Watts Bar Nuclear Plant, Unit 2  
NRC Docket No. 50-391

**Subject: WATTS BAR NUCLEAR PLANT (WBN) UNIT 2 – INSTRUMENTATION AND  
CONTROLS STAFF INFORMATION REQUESTS**

**Enclosure 1**  
**TVA Letter Dated November 24, 2010**  
**Responses to Licensee Open Items to be Resolved for SER Approval**

kristin@nec2/23/2010-L

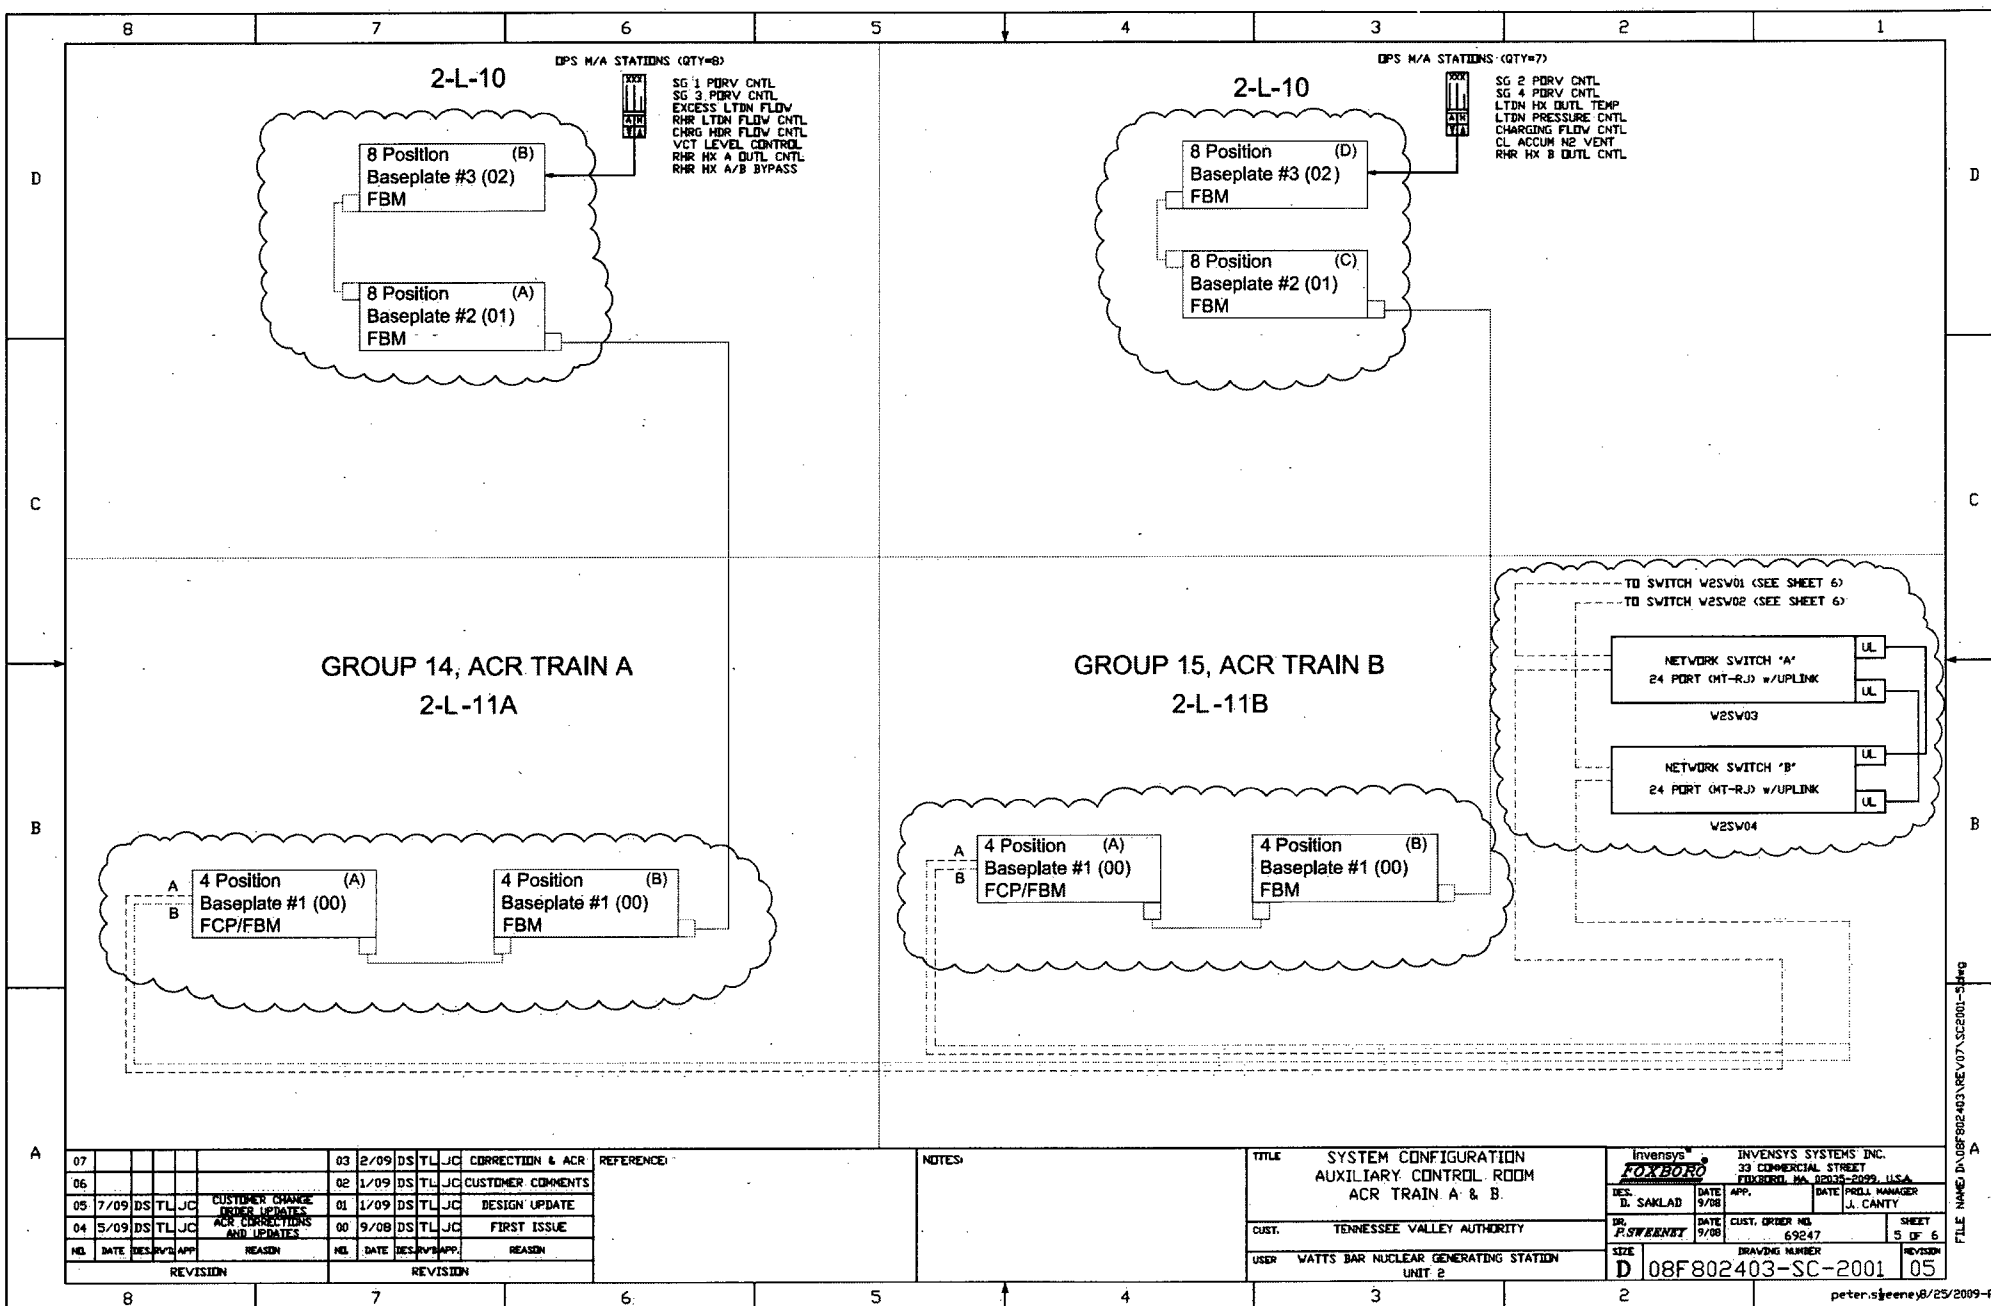
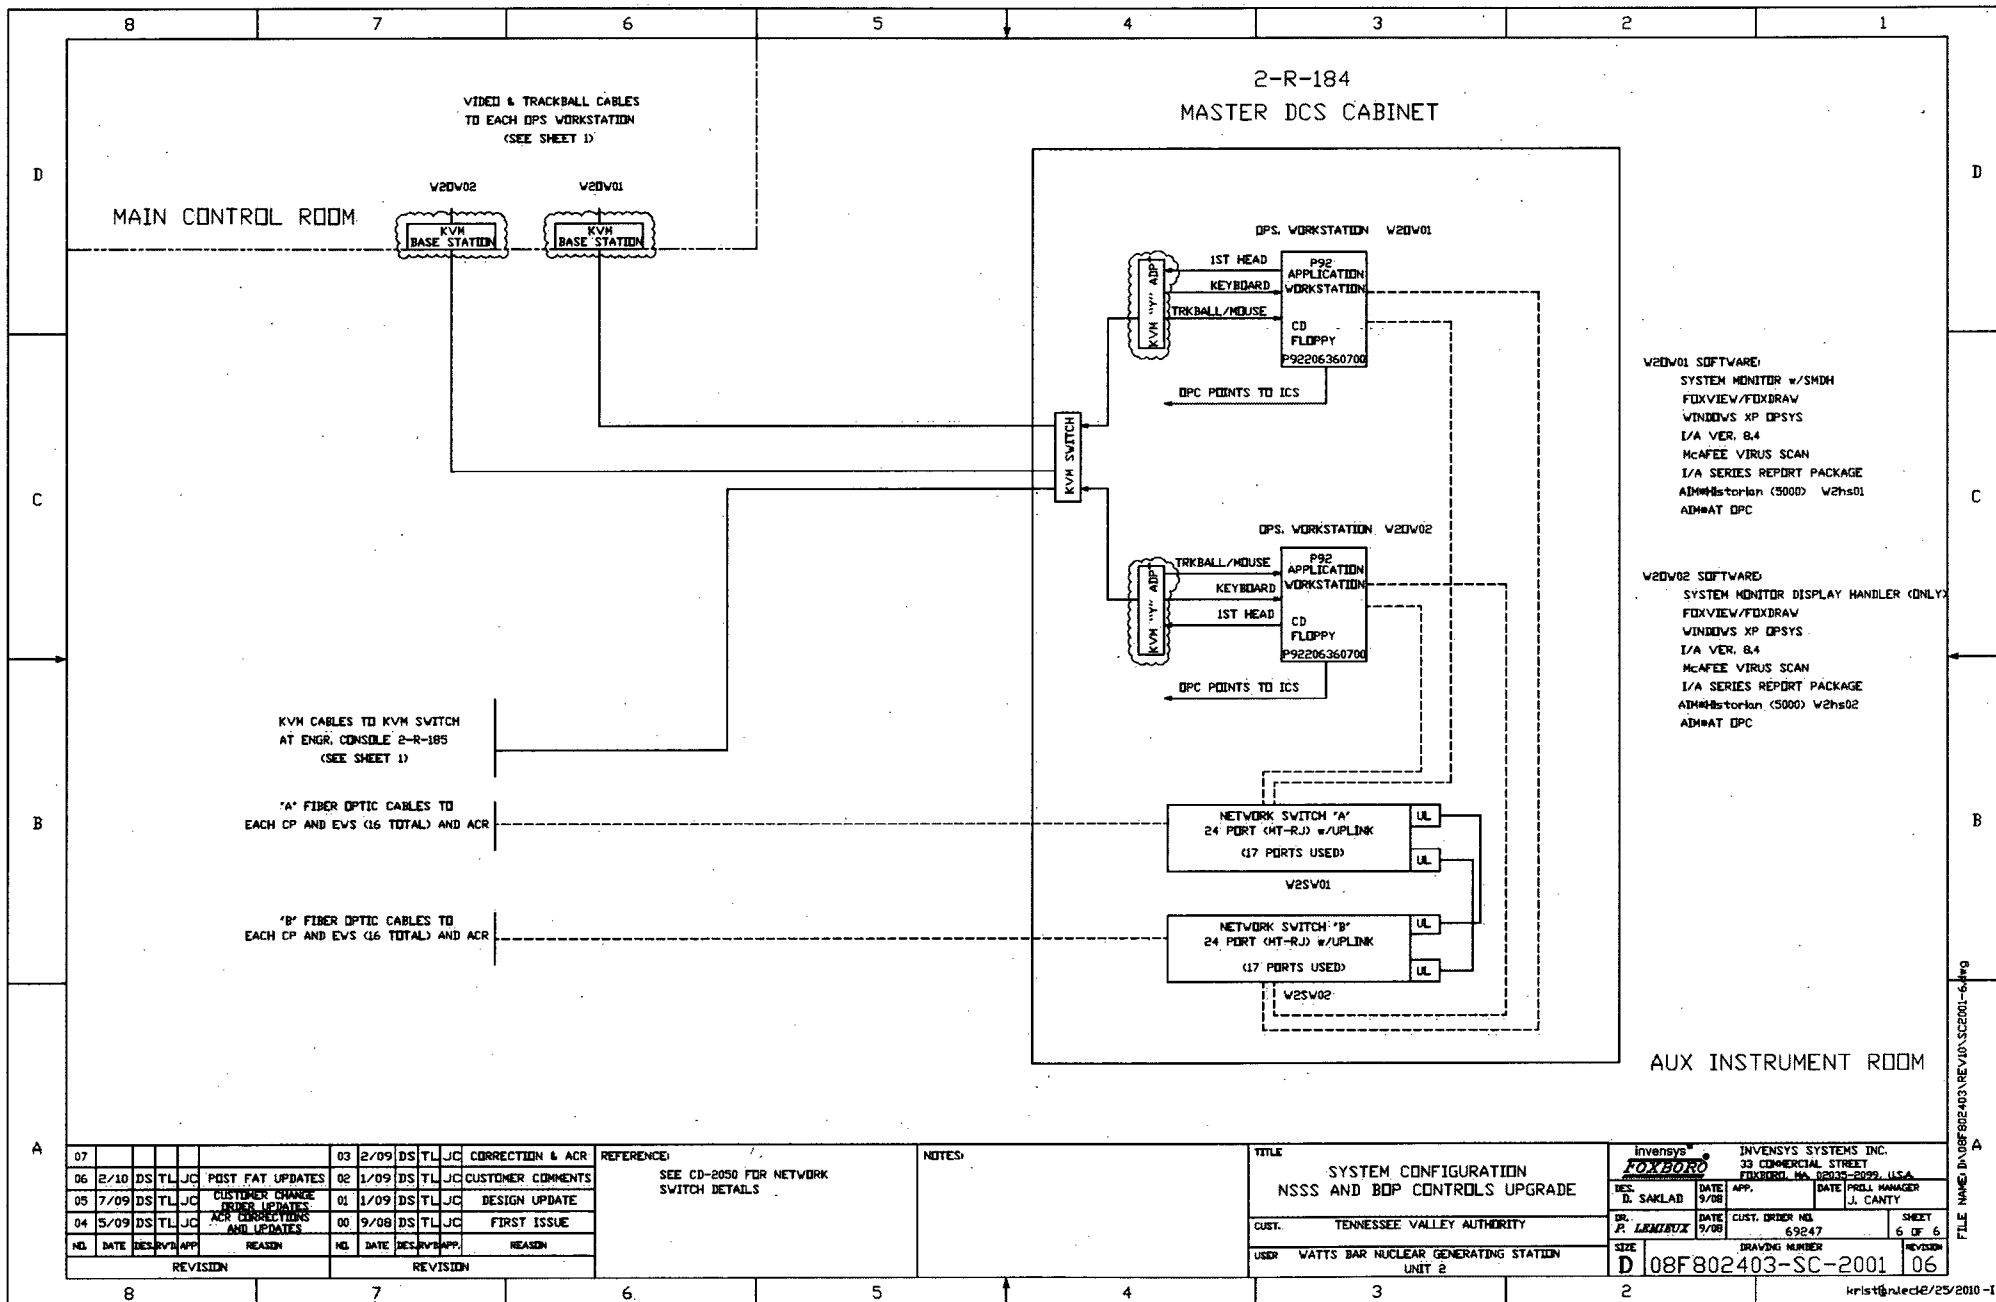
*Attachment 36 [of TVA to NRC Letter dated October 5, 2010 (Reference 2)] contains Foxboro proprietary drawings 08F802403-SC-2001 sheets 1 through 6. An affidavit for withholding and non-proprietary versions of the drawings will be submitted by January 31, 2011.*

In accordance with correspondence from Foxboro, there is no proprietary information contained in the 08F802403-SC-2001 drawings. Based on this, no affidavit for withholding is required. Attachment 1 contains versions of the drawings with the proprietary information block removed.
